Summary of Comments on Microsoft Word - 100.065-fdr

| Design Procedure Form: Extended Detention Basin (EDB) | |
|---|--|
| <p>Designer: R. Schindler</p> <p>Company: Core Engineering Group</p> <p>Date: April 14, 2022</p> <p>Project: Hillside at Lorson Ranch</p> <p>Location: Pond E1 - WQ pond</p> | <p style="text-align: right;">UD-BMP (Version 3.07, March 2018) Sheet 1 of 3</p> <hr/> <div style="display: flex;"> <div style="flex: 1; padding-right: 10px;"> <p>1. Basin Storage Volume</p> <p>A) Effective Imperviousness of Tributary Area, I_e</p> <p>B) Tributary Area's Imperviousness Ratio ($I = I_e / 100$)</p> <p>C) Contributing Watershed Area</p> <p>D) For Watersheds Outside of the Denver Region, Depth of Average Runoff Producing Storm</p> <p>E) Design Concept (Select EURV when also designing for flood control)</p> <p>F) Design Volume (WQCV) Based on 40-hour Drain Time $(V_{DESIGN} = (1.0 * (0.91 * P^2 - 1.19 * P + 0.78 * I) / 12 * Area))$</p> <p>G) For Watersheds Outside of the Denver Region, Water Quality Capture Volume (WQCV) Design Volume $(V_{WQCV OTHER} = (d_s * V_{DESIGN} / 0.43))$</p> <p>H) User Input of Water Quality Capture Volume (WQCV) Design Volume (Only if a different WQ

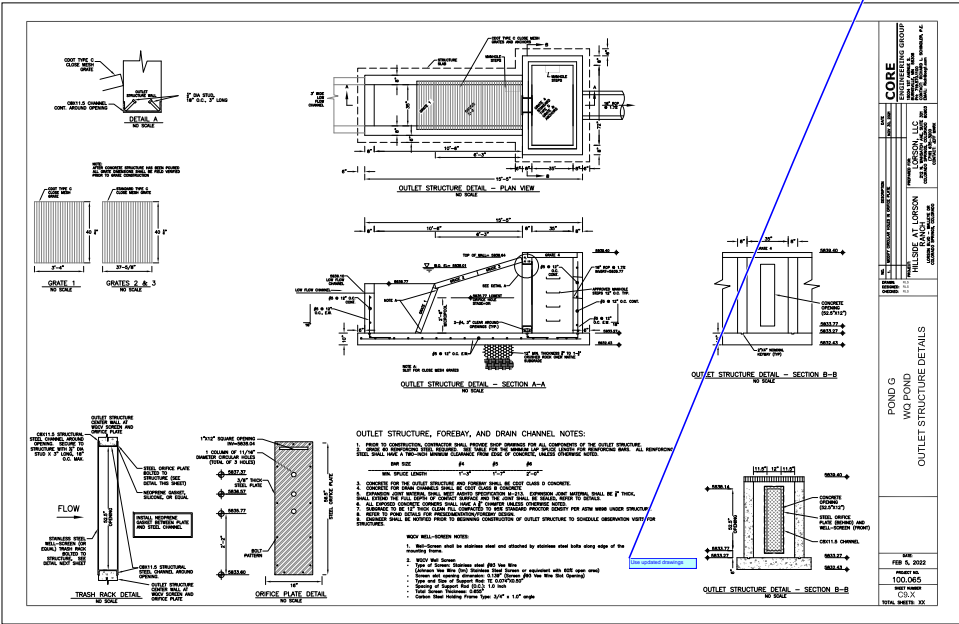
does not match what is shown on Sht C9.2 of GEC Plans. Revise to remove discrepancy.

Show maintenance access path to spreader

ADDED
